Title: **SATELLITE AMPLIFIER**
 Site: D Number: D961289 Revision: B2
 File: F:\Reel1\img\copy\table\Nov04\TAB-000300-00-01.MXD Date: 03/16/05 Page: 1 of 1
 LIGO

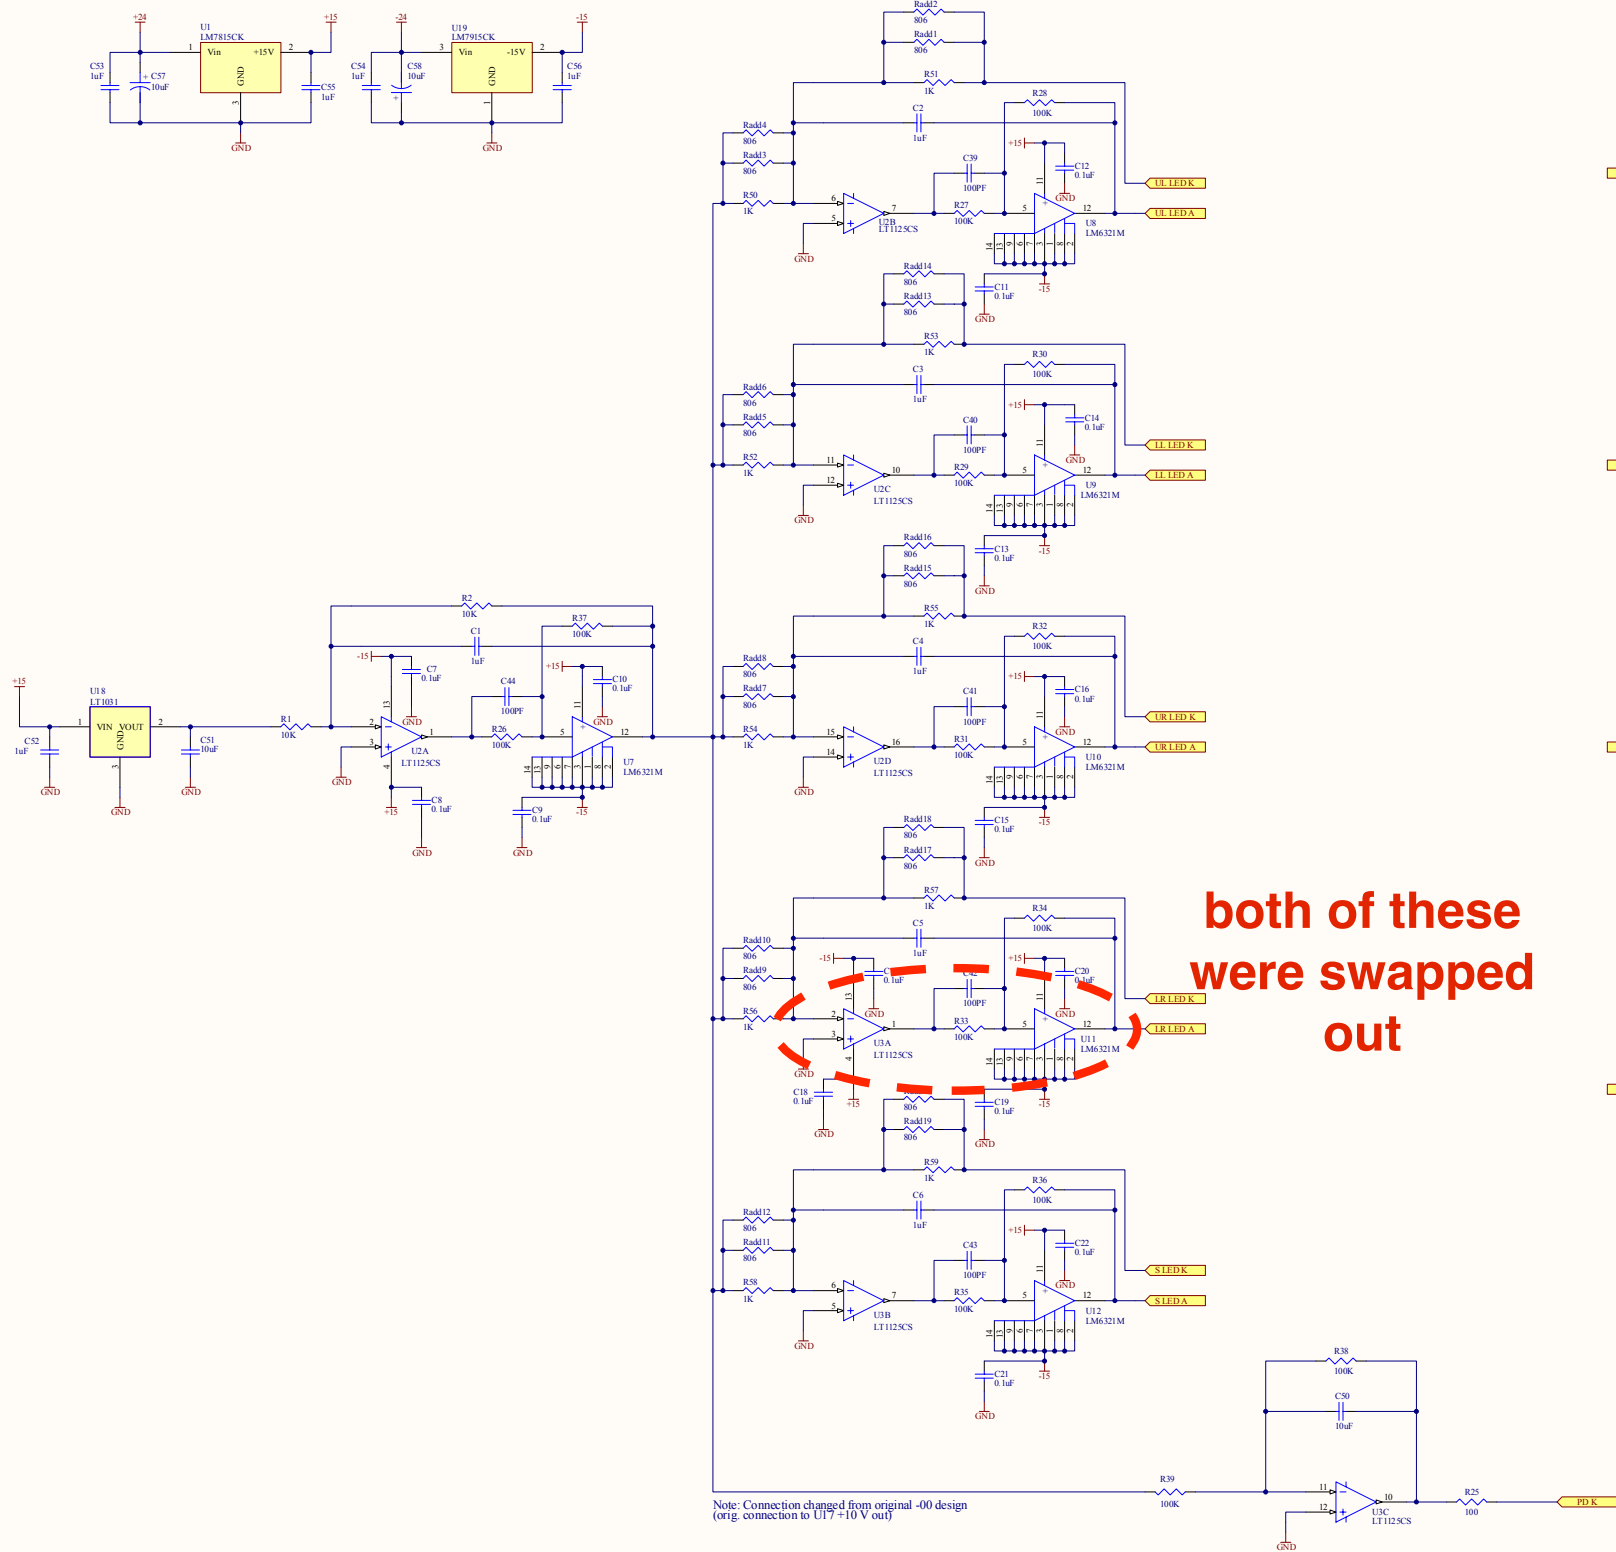
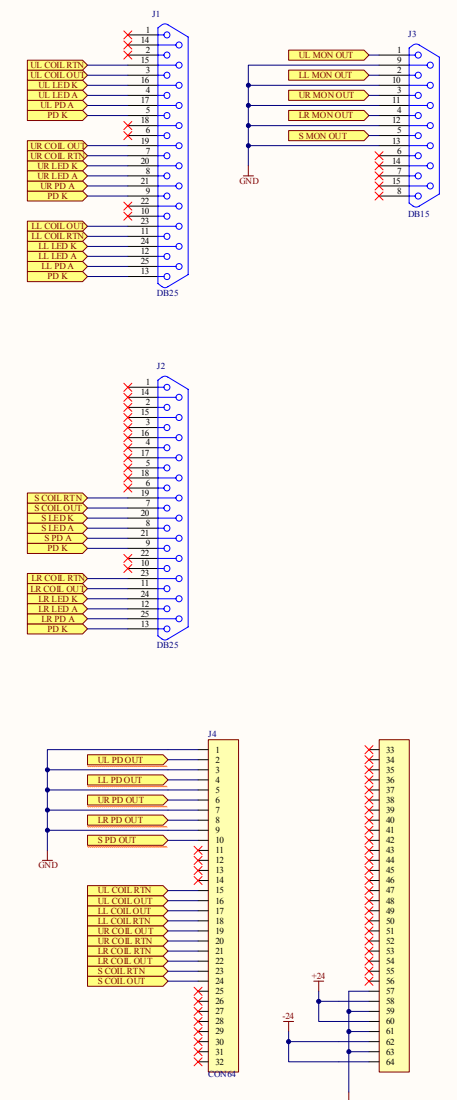
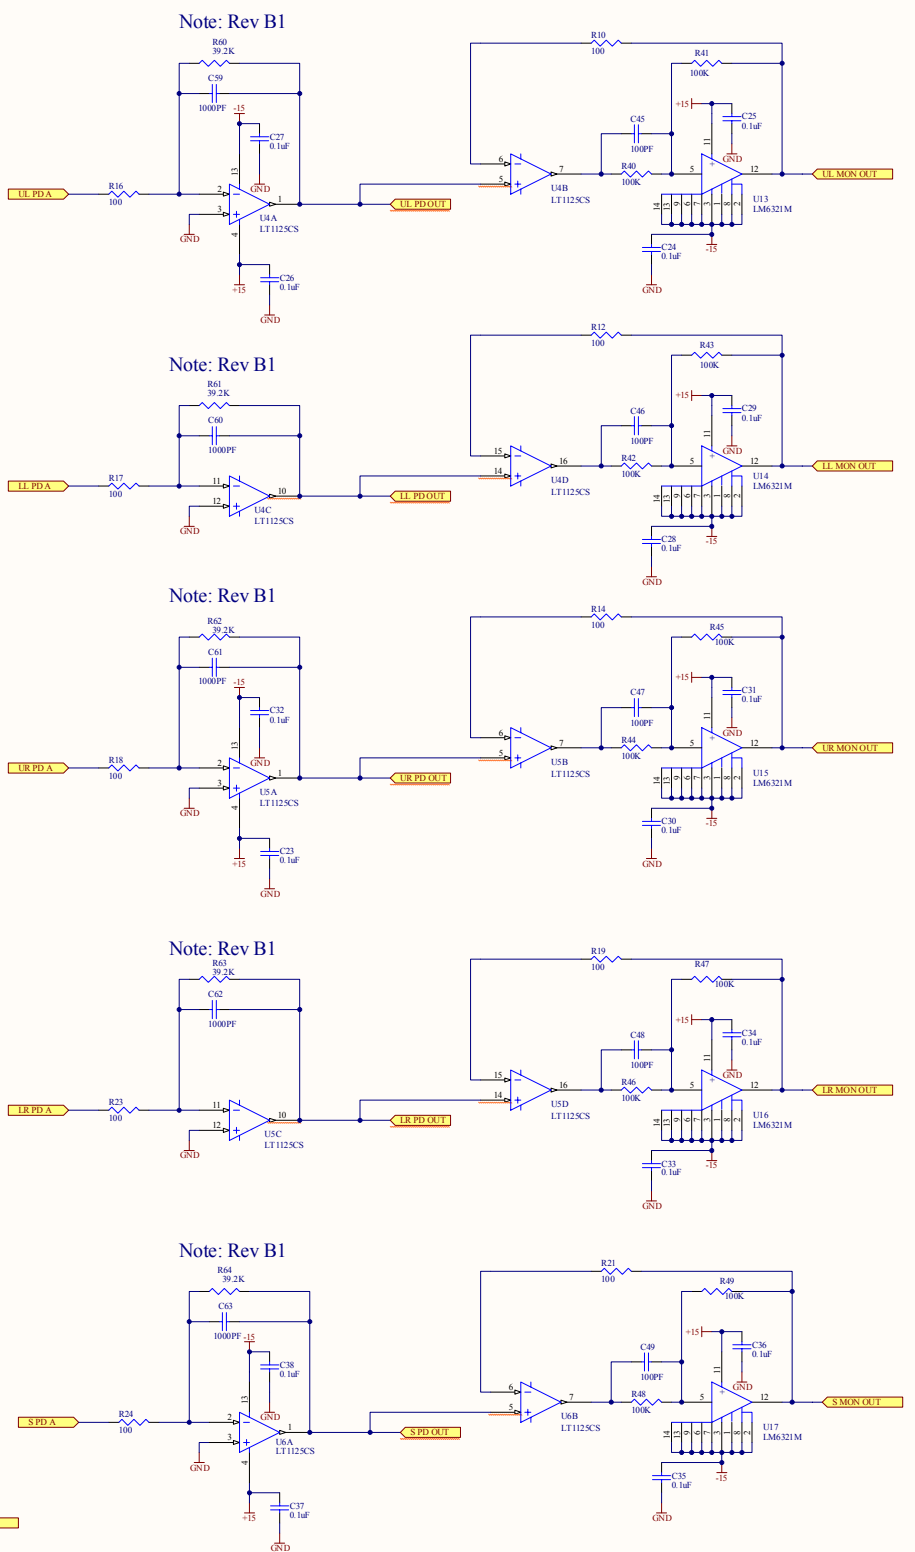
LED drive current = 25mA

both of these were swapped out

| Rev | Description | Date |
|-----|--|-------|
| B | 1. Rad41 through Rad40 added to increase LED drive to 25mA 2. R60, R61, R62, R63, R64 changed to 39.2K to increase IV gain for new OS&Ms. | 8/01 |
| B1 | R60, R61, R62, R63, R64 may be changed to 29.4K for operation on CIT 40 M. | 2/04 |
| B2 | Added note about need for satellite amplifier termination board (D990021-00) | 1/05 |
